CARNEGIE FORUM 305 WEST PINE STREET LODI, CALIFORNIA	AGENDA LODI SITE PLAN & ARCHITECTURAL REVIEW COMMITTEE	REGULAR SESSION WEDNESDAY, APRIL 10, 2019 @ 5:15 PM
---	---	--

CITY OF LODI
SITE PLAN AND ARCHITECTURAL REVIEW COMMITTEE
Staff Report

APPLICATION NO: 2019-01 SP

REQUEST: Request of Site Plan and Architecture Review Committee (SPARC) to consider Site Plan and Architectural Review for a new food and meat commissary with 21,000 sq ft building and food truck and trailer storage at 1365 East Lockeford Street (Applicant: Commissary El Gallo - Conrado and Alberto Marquez; File Number: 2019-06 SP; CEQA Determination: Exempt Per Section 15332)

MEZZANINE FLOOR PLAN

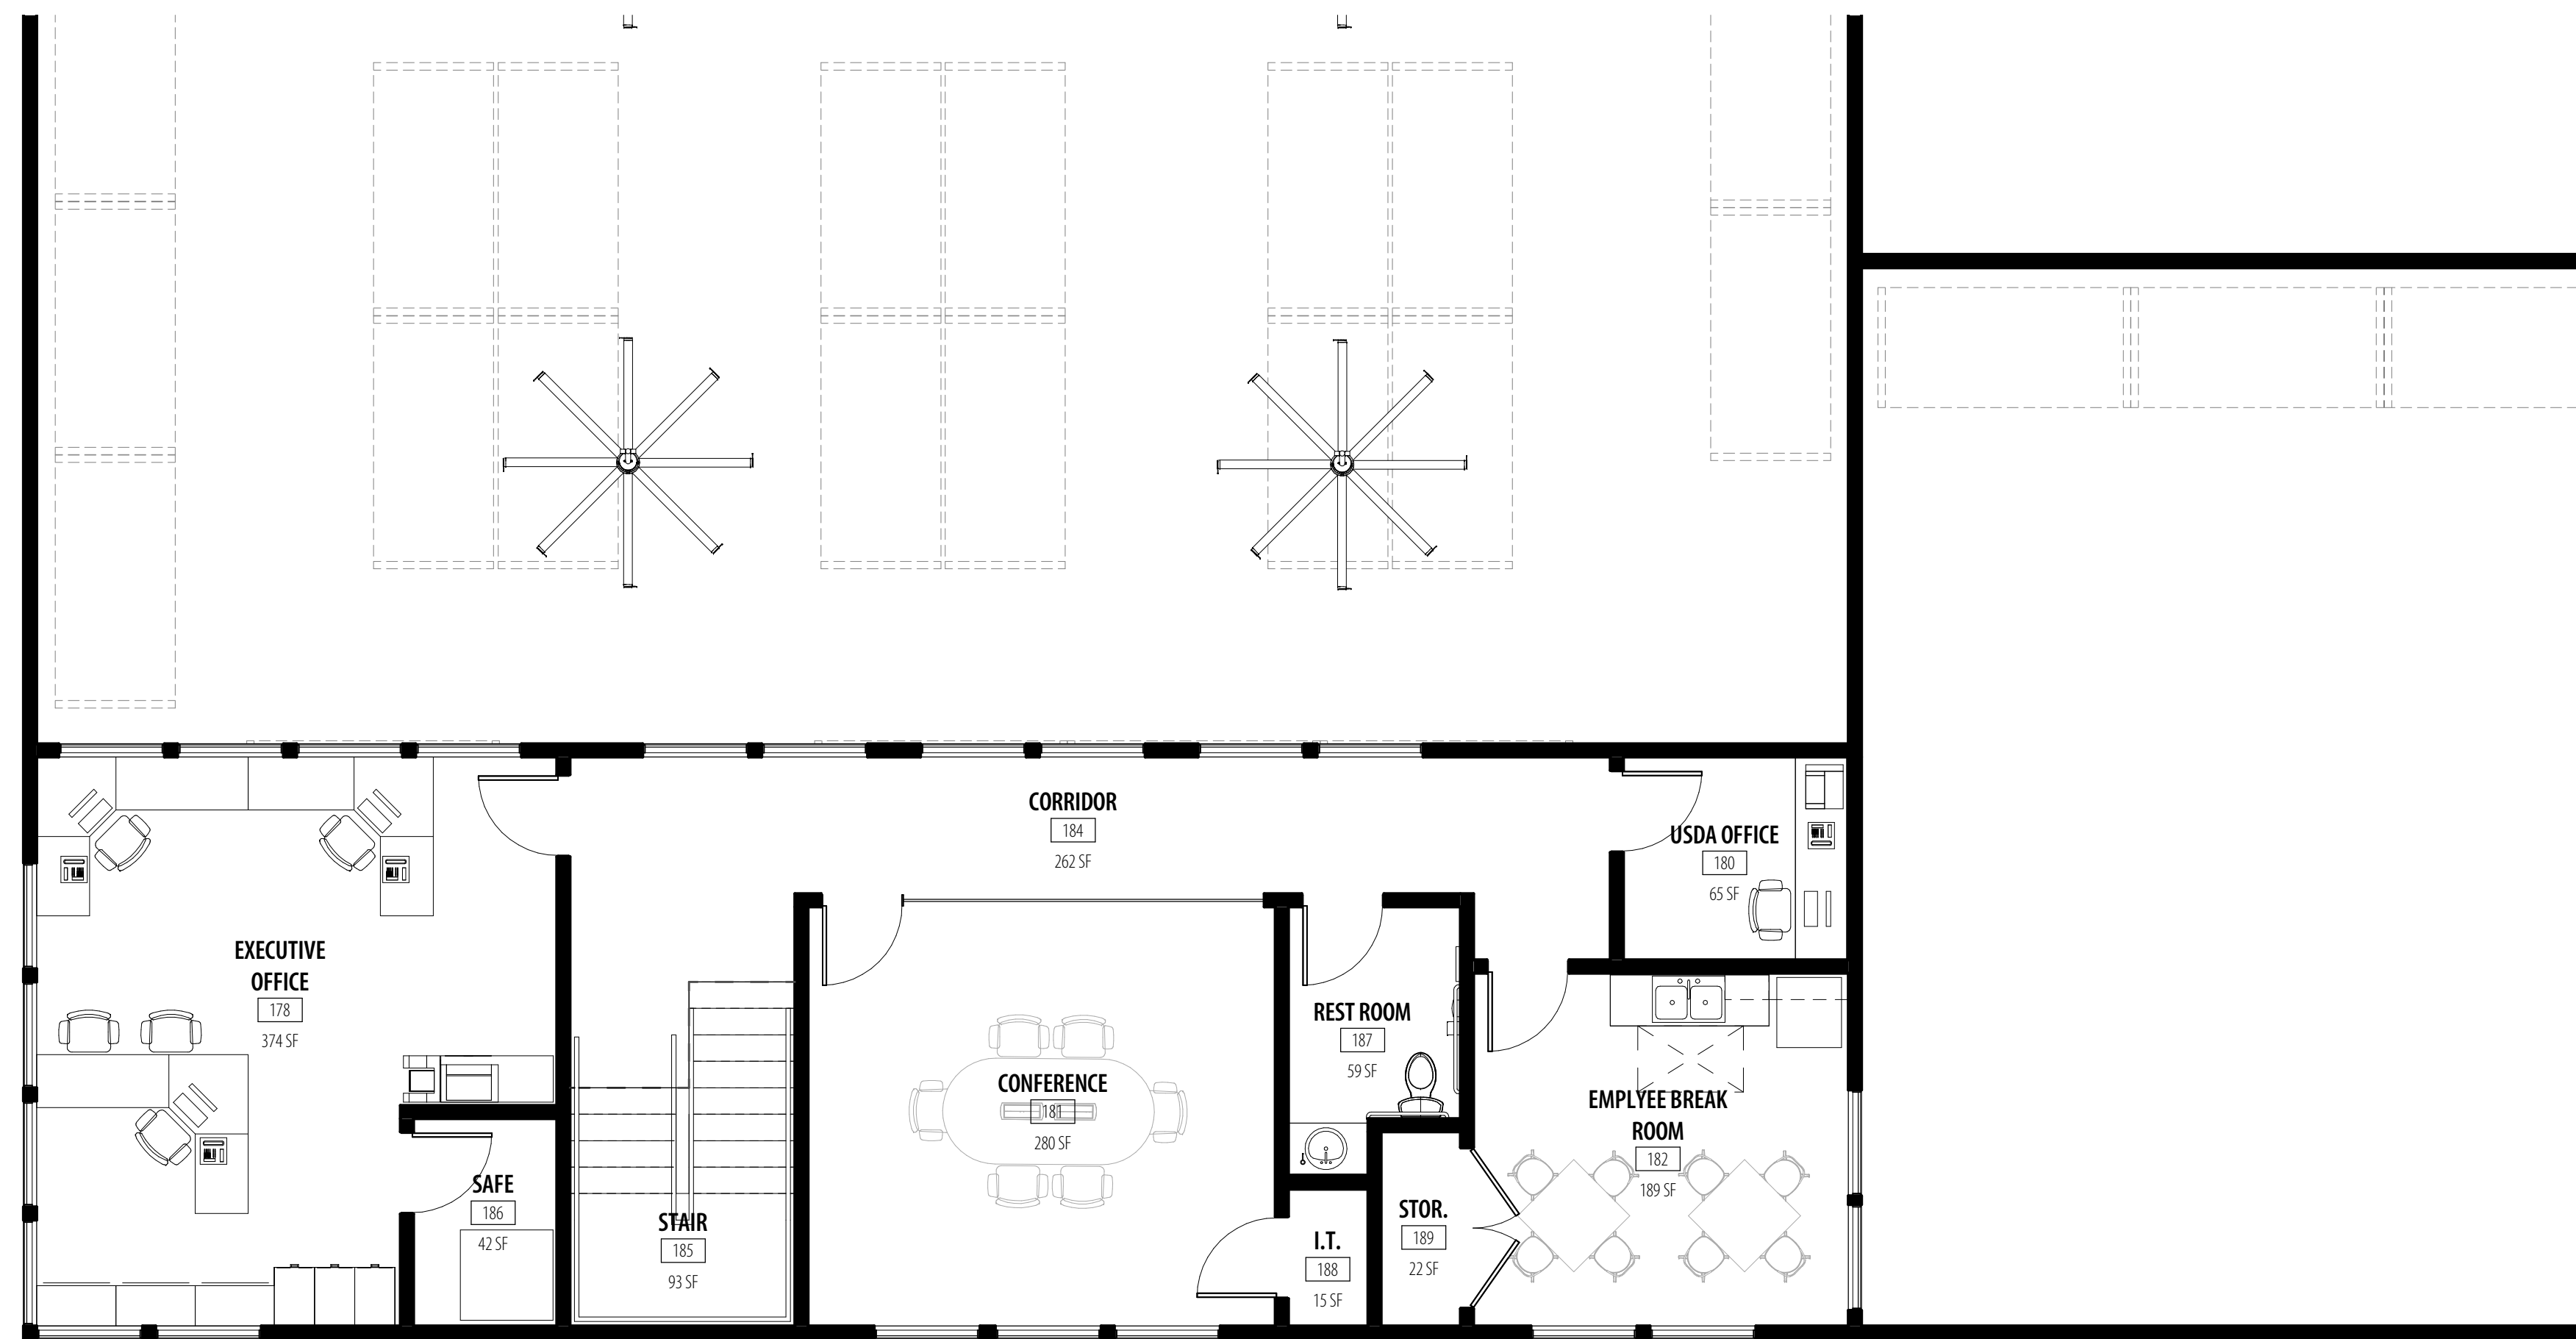
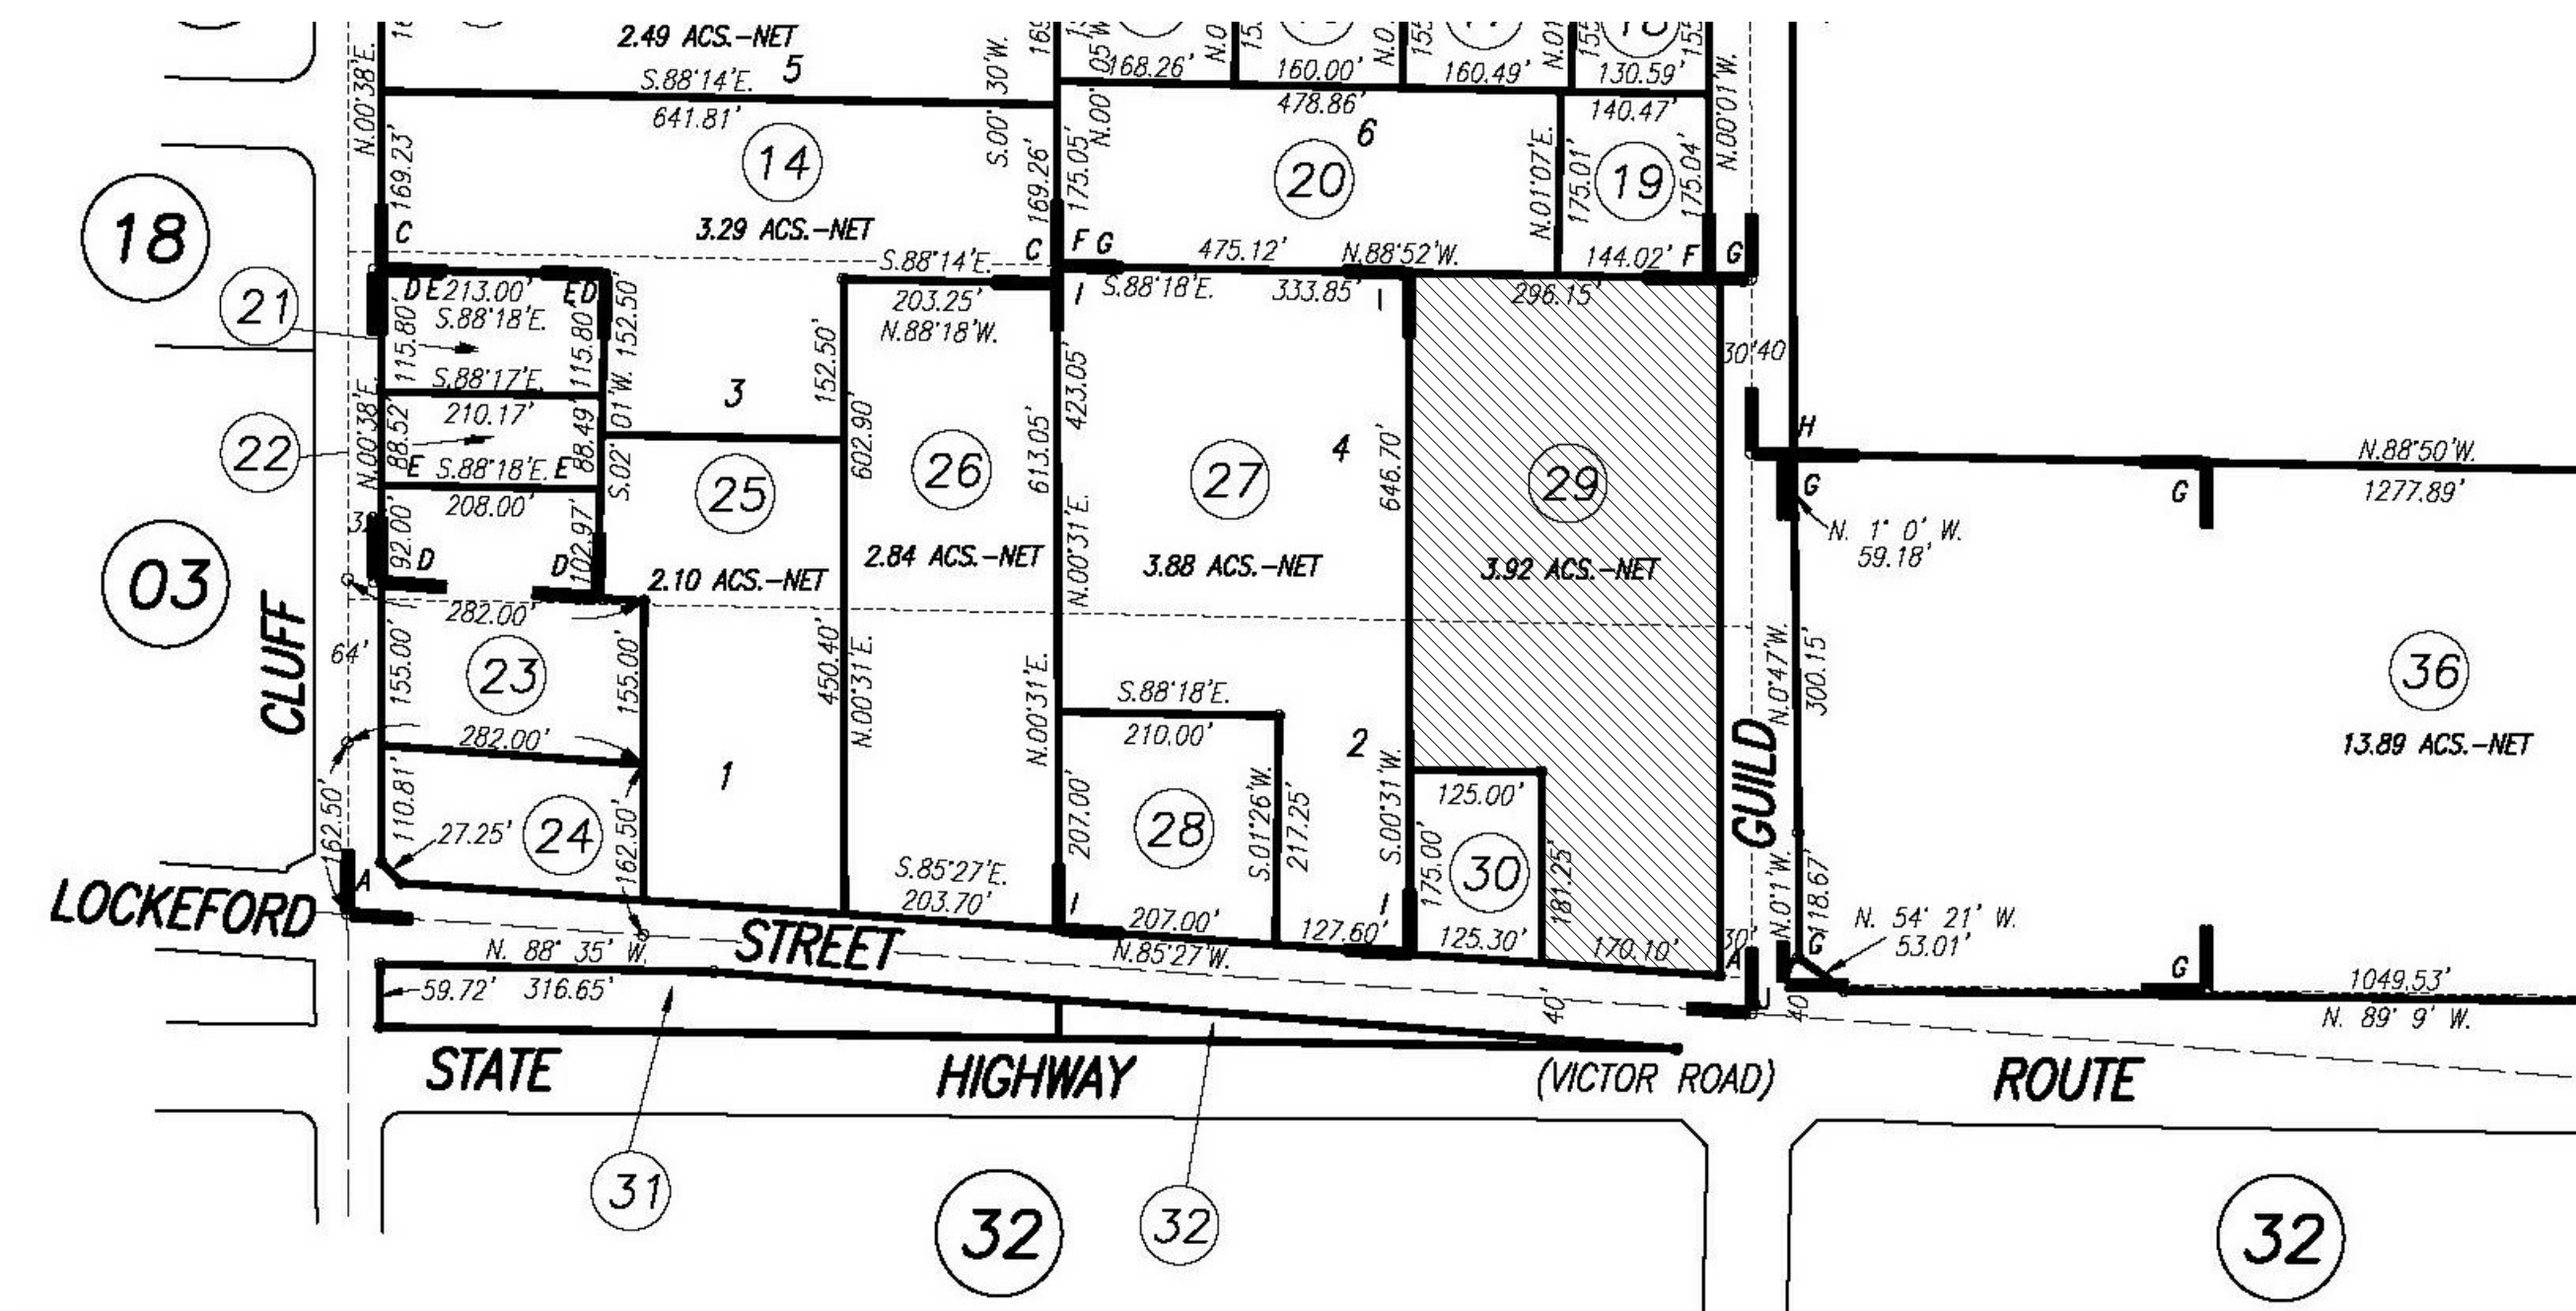
26. Mezzanines are required to be open and unobstructed to the room in which the mezzanine is located. Unless meeting one of the exceptions of the 2016 CBC, Section 505.2.3 the mezzanine appears to be a story [DSA-AC], as defined by 2016 CBC, Section 202.

27. The 2nd floor (or mezzanine) contains executive offices, conference room, break room and a USDA office. These facilities are not shown on the ground floor (no equal facilitation). Plans to provide complete and adequate details for elevator or ramp to serve the second floor (mezzanine). 2016 CBC, Section 11B-206.2.3

1 SITE PLAN
SD.3 1" = 30'-0"

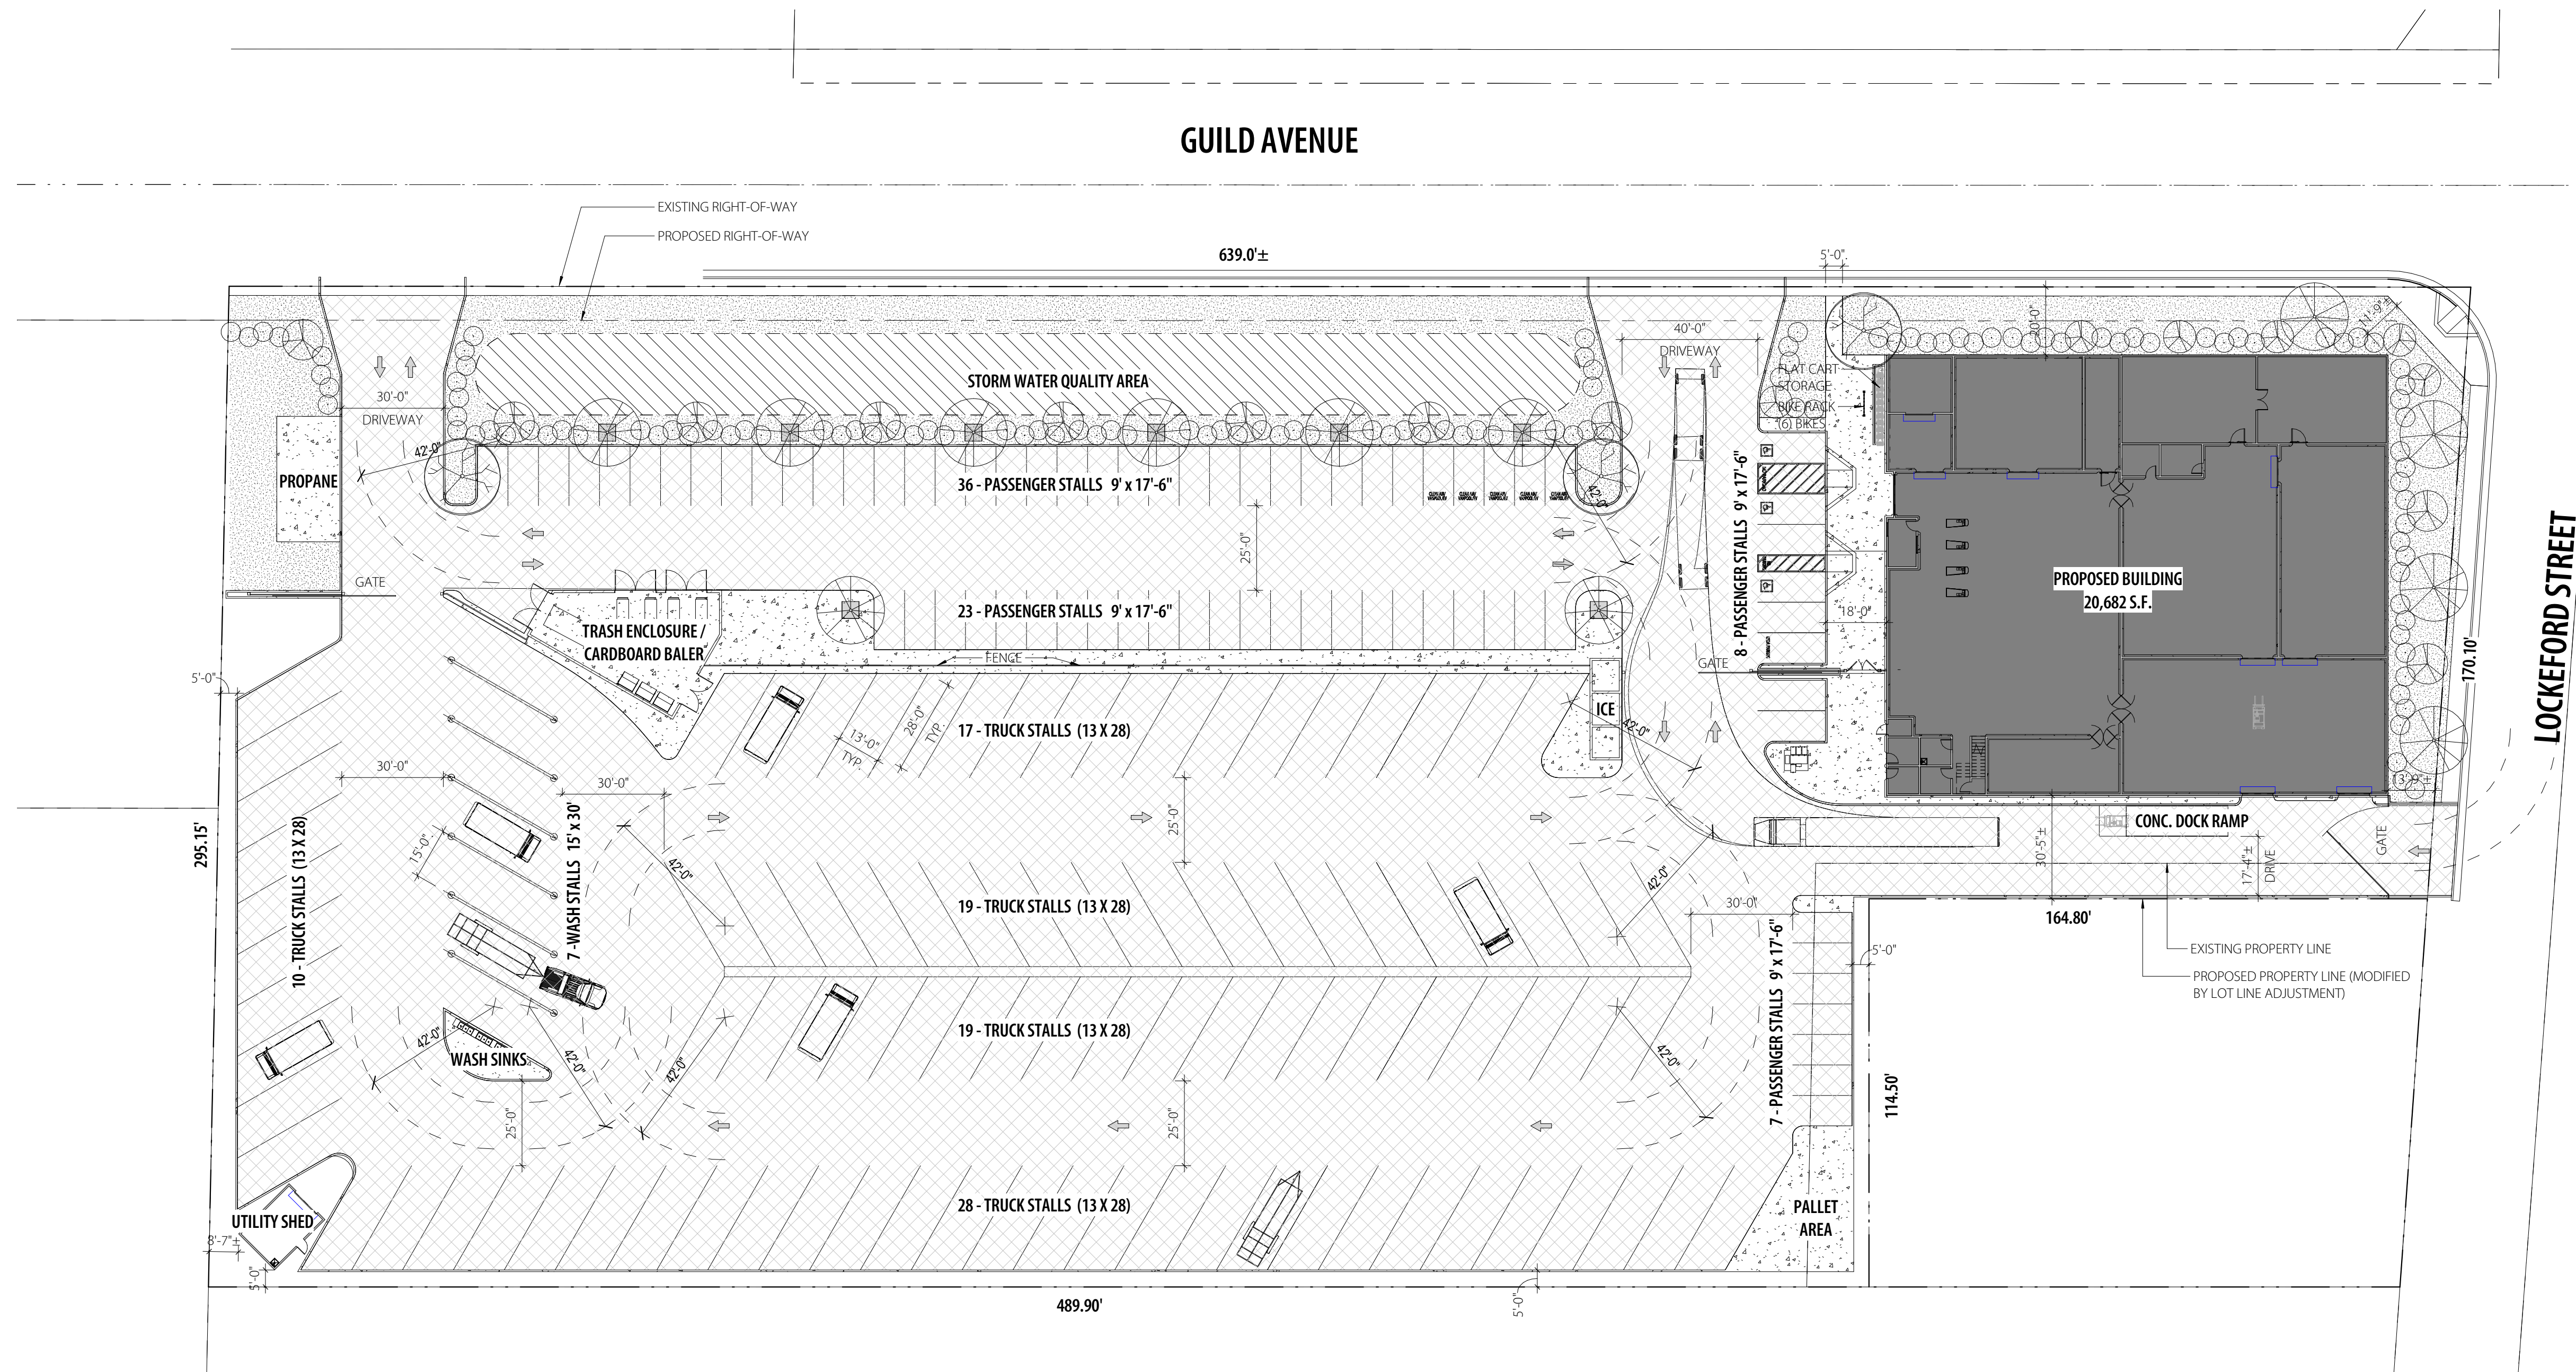
36. Plans to specify and show a fire access lane to extend within 150' of all portions of the structure. Fire access lane to be a minimum of 24' wide. Dead end fire access lanes in excess of 150' in length shall be provided with an approved area for turning around fire apparatus. Further, amend plans to specify and show fire lane striping (red curb or stripe with "Fire Lane" in 4" high white letters, ¾" stroke at intervals not less than 50') and fire lane sign at the entrance and the extremity of the lane. 2016 CFC, Section 503.1 and LMC 15.20.080
